MIL-E-63124A(AR)
AMENDMENT 2
7 September 1982
SUPERSEDING
AMENDMENT 1
24 MAY 1982

MILITARY SPECIFICATION

ELECTRONICS MODULE ASSEMBLY

FIGURE 1 Dispense signal

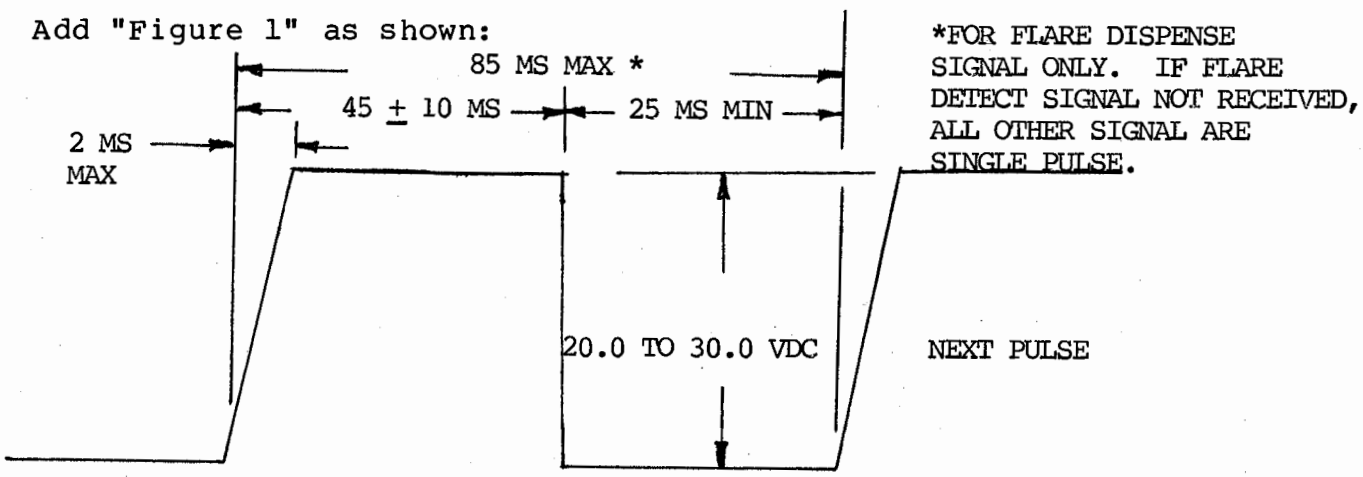
* 3.3.3, Change to read:

"The electronics module shall provide two outputs of 20.0 to 30.0 volts direct current (DC), a chaff dispense signal and a flare dispense signal, with characteristics conforming to Figure 1. These outputs shall be initiated by the respective input signals".

Add "Figure 1" as shown:

* 3.3.5, Change to read:

"A chaff count signal or a flare count signal shall be generated each time a chaff or flare is dispensed. Both count signals shall conform to Figure 1".
